The Brightview Senior Living Facility consists of qty (4) DOAS systems. Each system has a heat wheel with supply & exhaust fans. Our focus for our analysis was DOAS-1, which serves the 1st floor Wing A area. There have been multiple testing agencies on site to evaluate the system each time returning data with conflicting information. The purpose of this analysis was to provide data that could have more conclusive results and a possible understanding of why different results were measured by different testing firms.

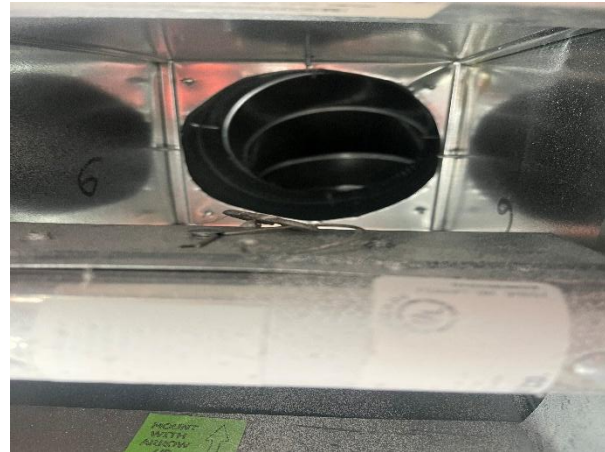
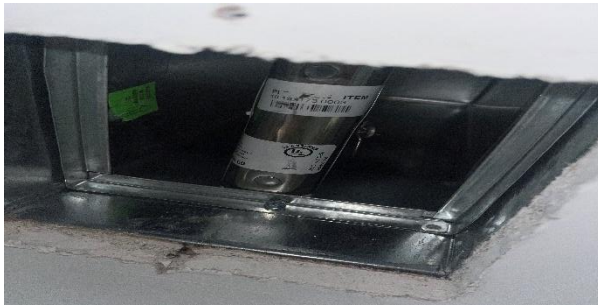
Per DJW DOAS filters have been replaced and Heat Wheel cleaned and serviced by facility staff prior to our testing. New filters were found inside the unit at time of testing. All doors have had additional foam added to seal gaps and to prevent leakage. No air supply/exhaust leakage could be felt around any access doors indicating the unit is well sealed. The only spot we're there could be some short cycling is a bracket piece on the inside of the unit that is located in the coil/filter compartment. There was about a 1/8" gap (picture below) which most likely is negligible leakage.
